re: Geotechnical Review – Grading Plan Review
Proposed Residential Development
3317 Navan Road - Ottawa, Ontario

date: February 27, 2024

file: PG6582-MEMO.04

PG6582 - Light Weight Fill markup - Series

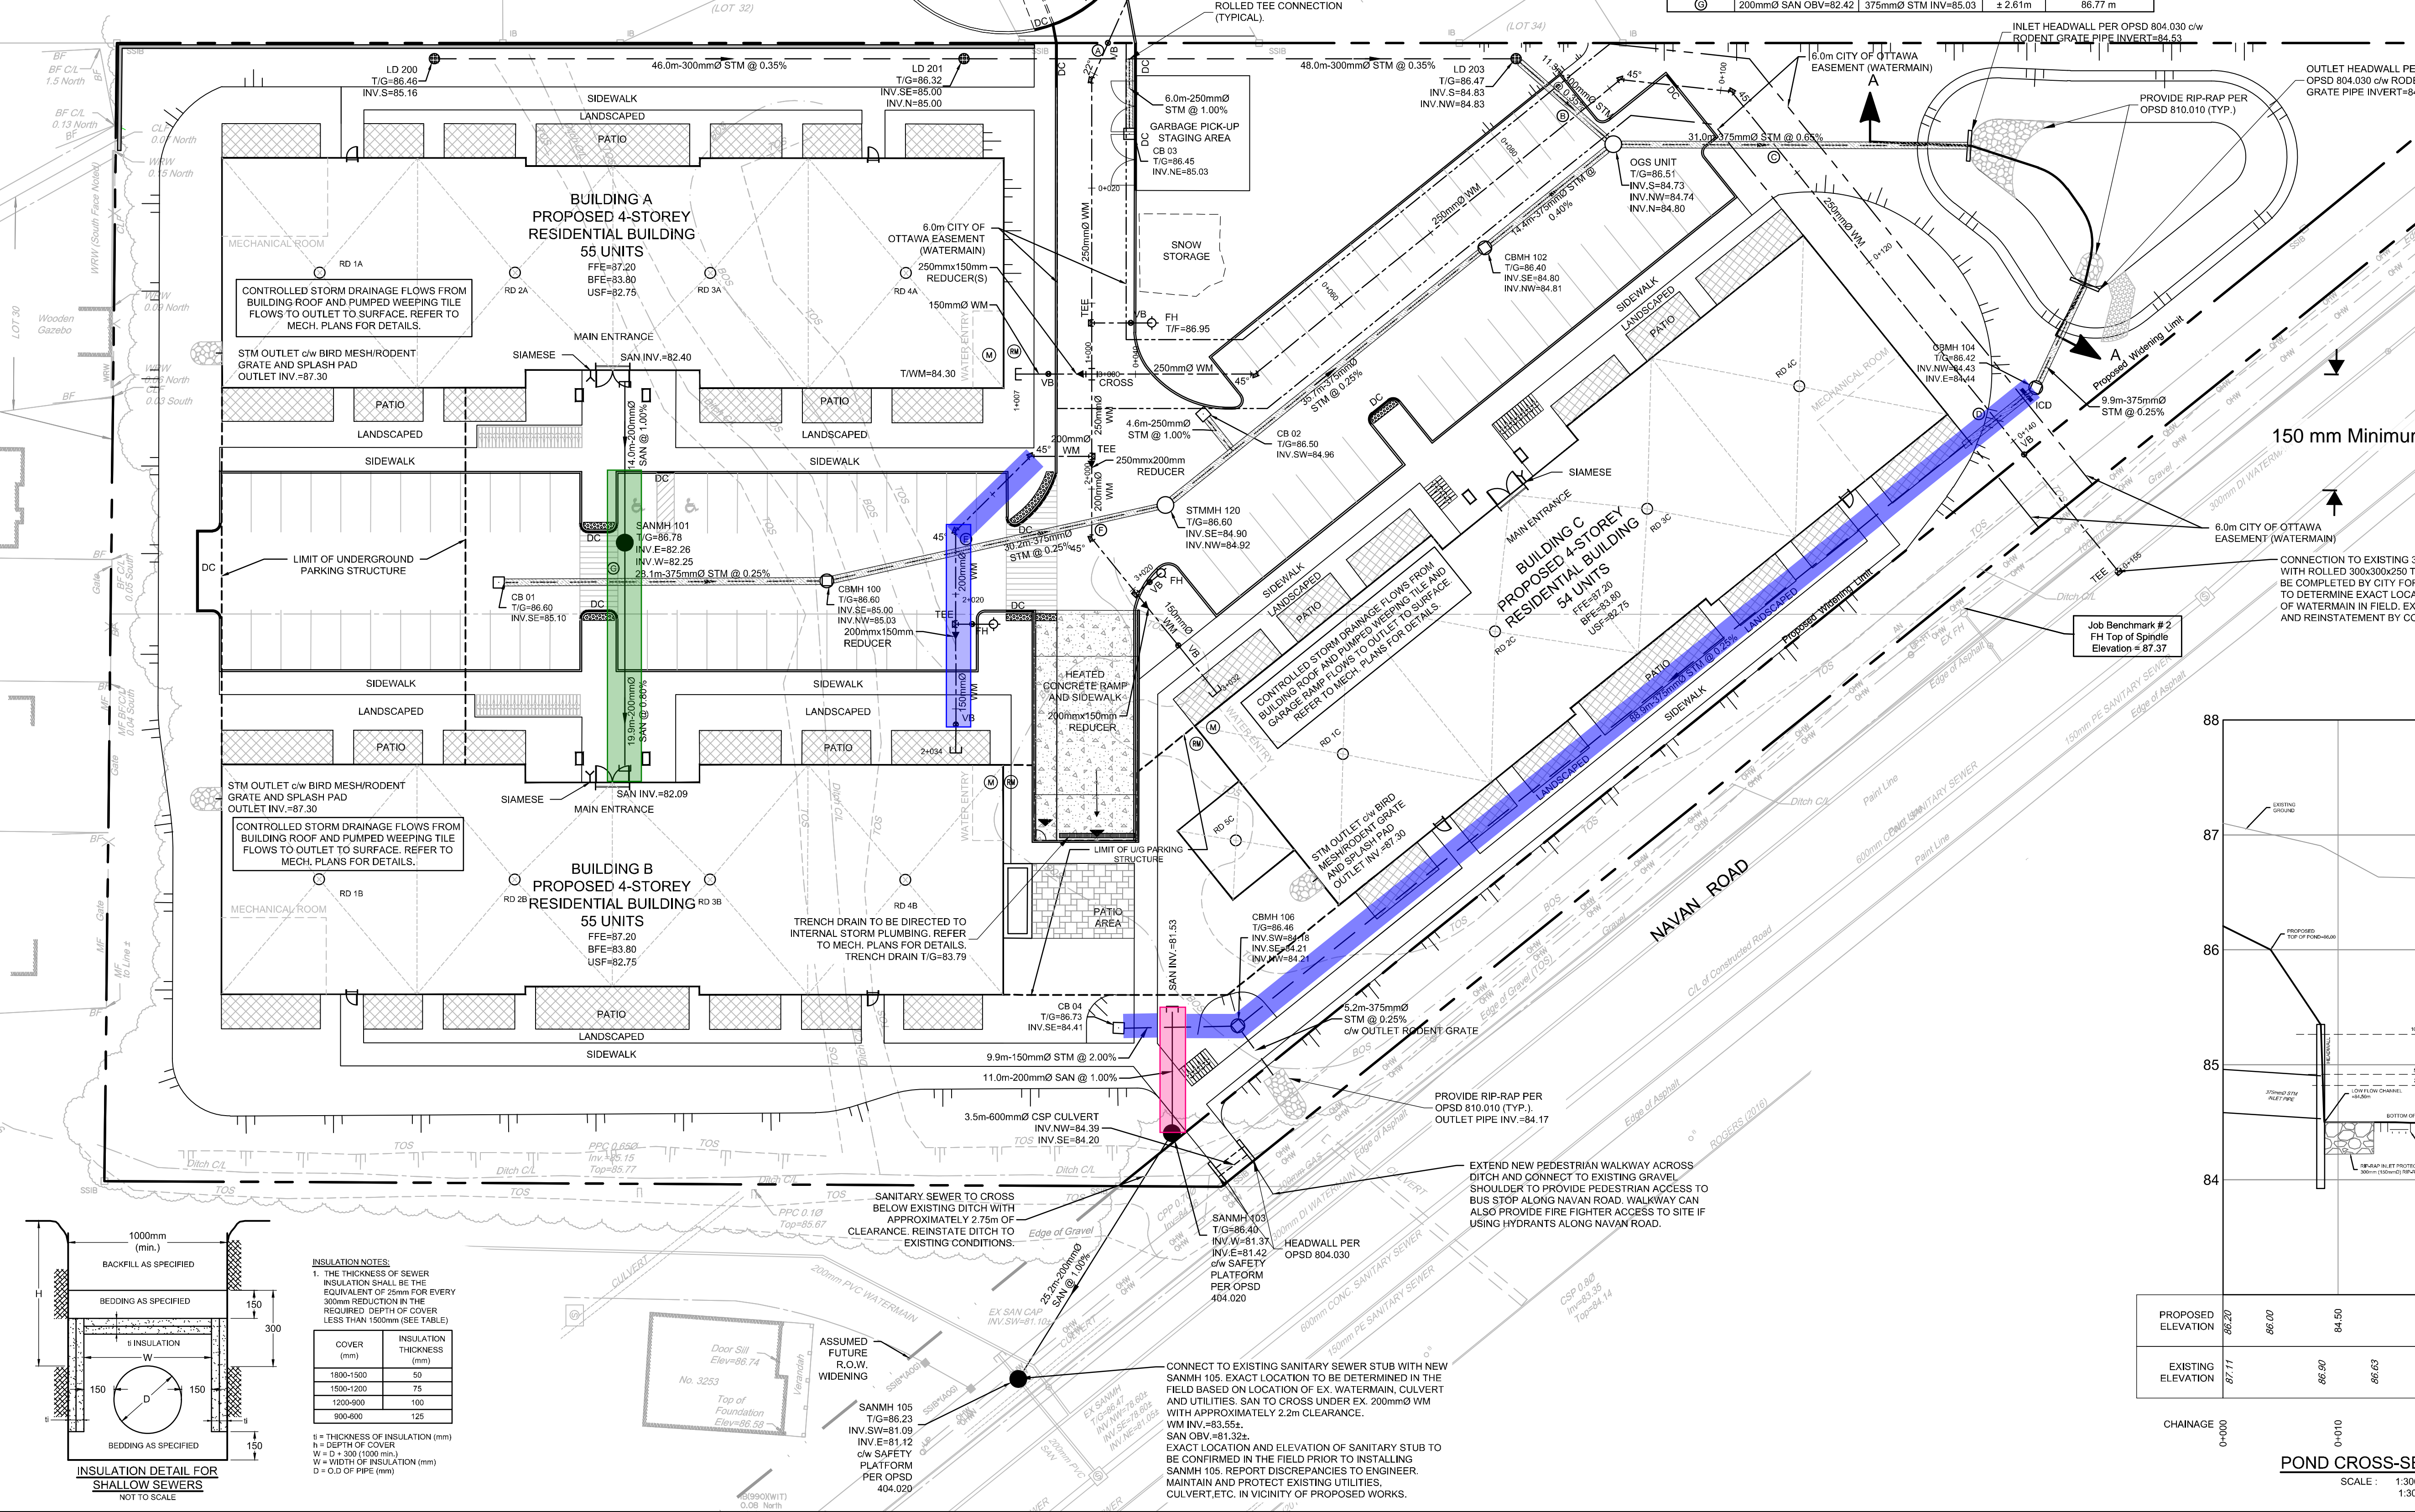
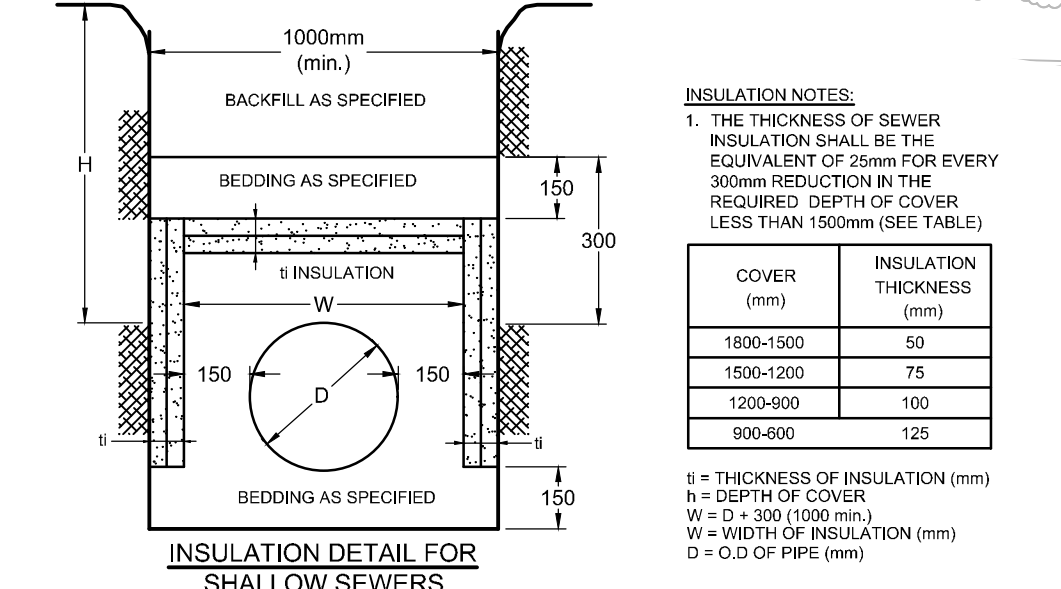
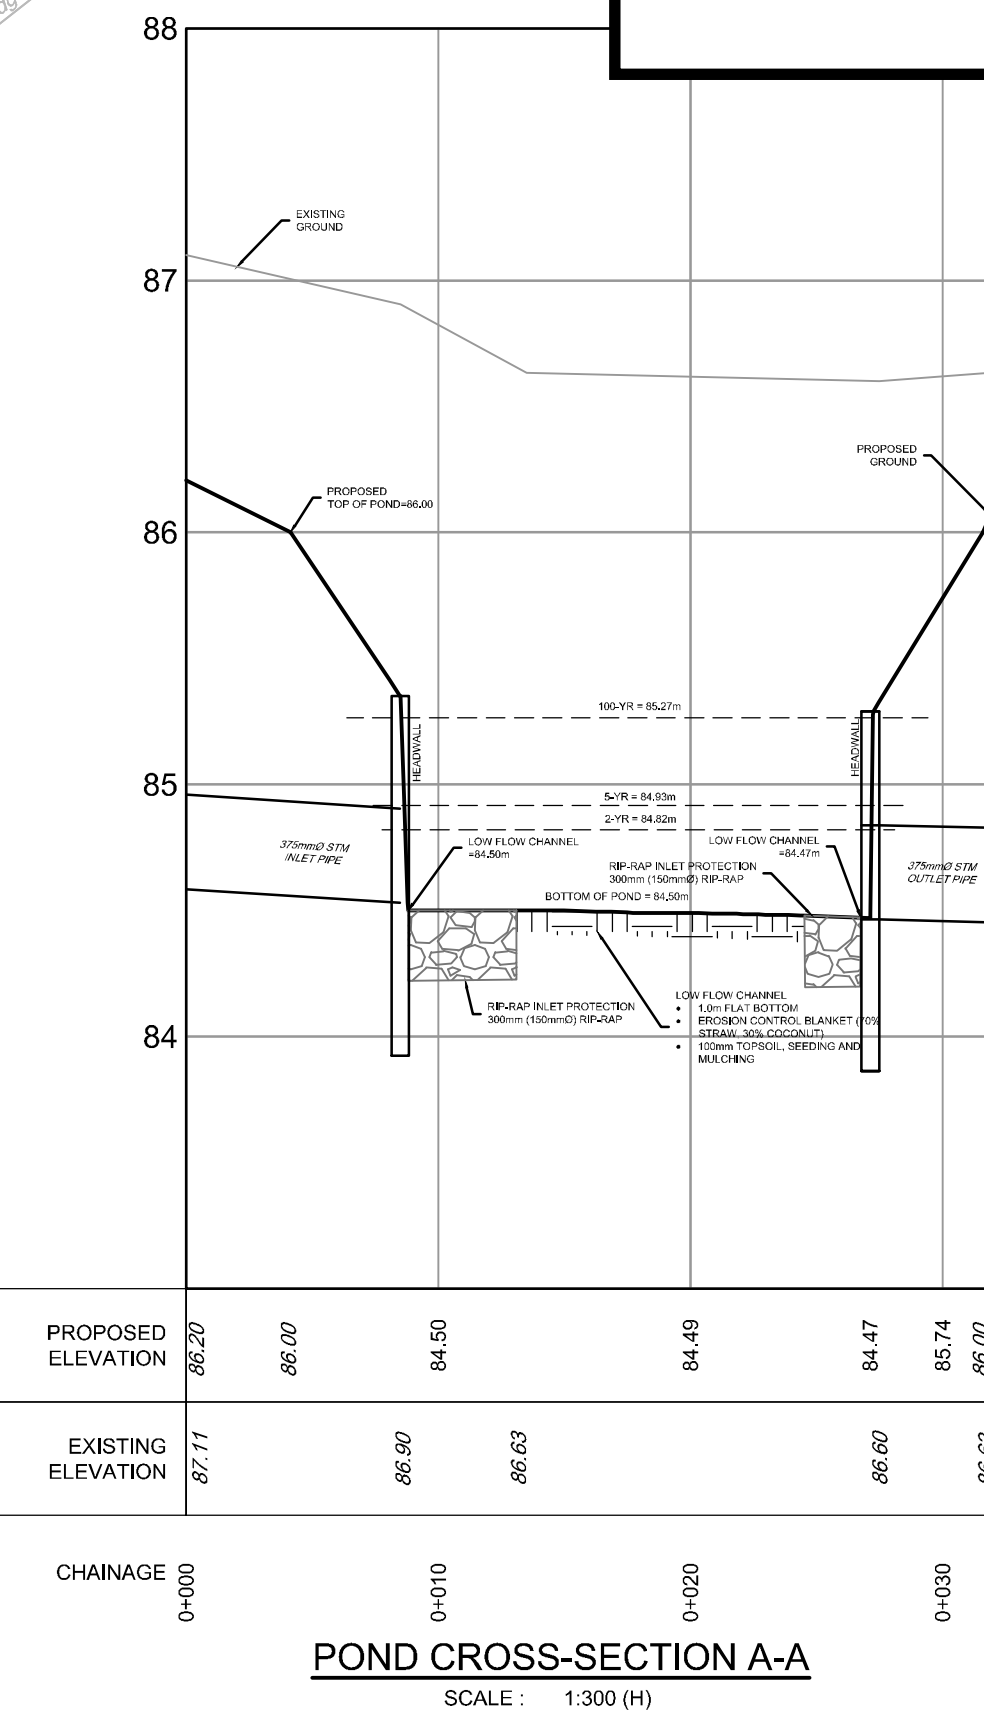
Based on our review of the grading plan, it was found that the several deep services were observed. It is recommended to place LWF above the services where a grade raise exceedance has been observed. Our lightweight fill recommendations are presented in the grading plan attached to the end of this report. It is recommended to place EPS-15 LWF, surrounded by a non-woven geotextile such as Terrafix 270R above the service pipes.

Furthermore, based on the abovementioned site plans, it was noted that the proposed invert elevation of the sanitary service line from SANMH103 and SANMH 101 located along the eastern side building was observed to be located below the proposed USF elevation of the buildings. In order to avoid undermining the footings and to protect the service pipes from the footing loads, one of the following options can be followed:

Note: EPS 15 LWF should be placed above the service pipes and surrounded by non-woven geotextile.

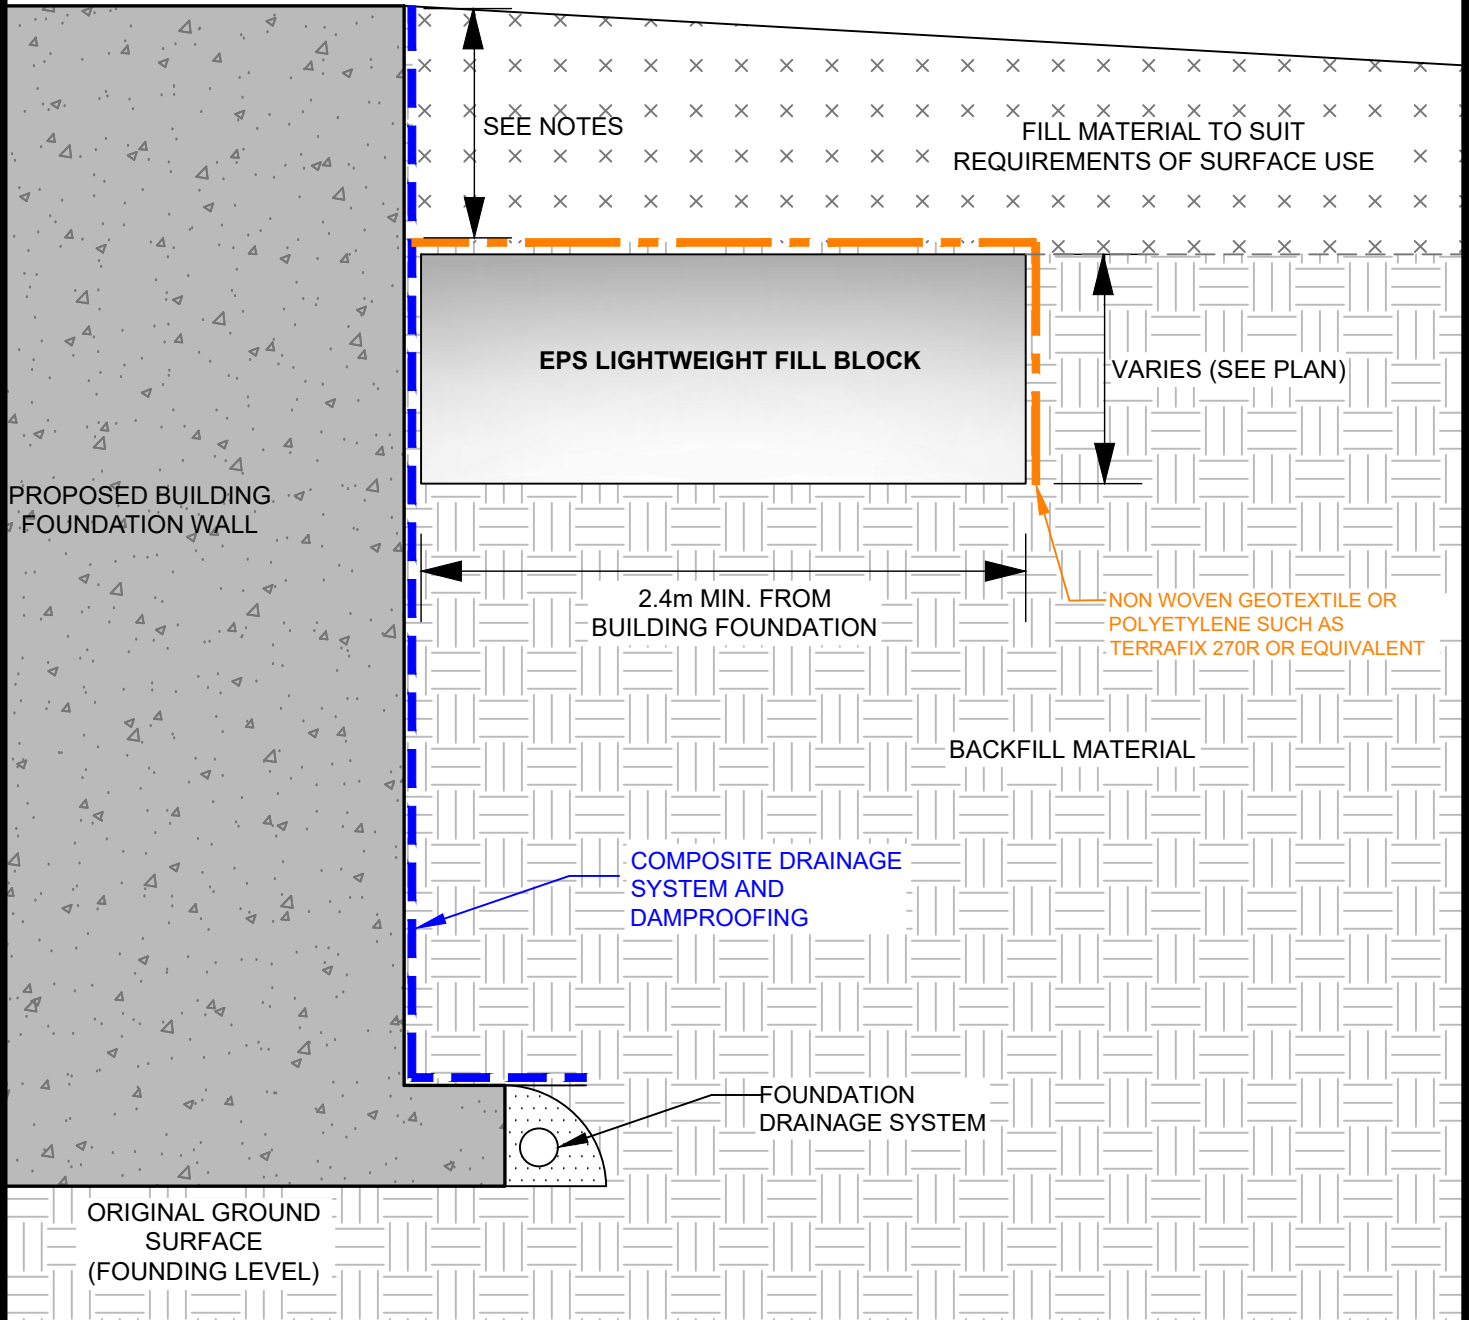
Lightweight fill material specifications and cover recommendations are provided in Figure 1 attached to the current report.

1. USE EPS 15 AROUND THE BUILDING AND UNDER PAVEMENT STRUCTURES
2. USE EPS 12 BELOW SOFT LANDSCAPED AREAS AND MINIMUM 500 MM OF APPROVED BACKFILL TOPPED WITH A MINIMUM OF 150 MM OF TOPSOIL SHOULD BE PLACED OVER THE LWF UNDER SOFT LANDSCAPED AREAS.
3. MINIMUM 300mm OF OPSS GRANULAR A SHOULD BE PLACED OVER THE LIGHTWEIGHT FILL UNDER PAVEMENT STRUCTURES AND OTHER PARKING STRUCTURES.
4. PLACEMENT OF LIGHTWEIGHT FILL SHOULD BE A ON A LEVELED SURFACE.(SAND OR STONE DUST CAN BE USED TO PROVIDE AND ADEQUATE LEVELING SURFACE)
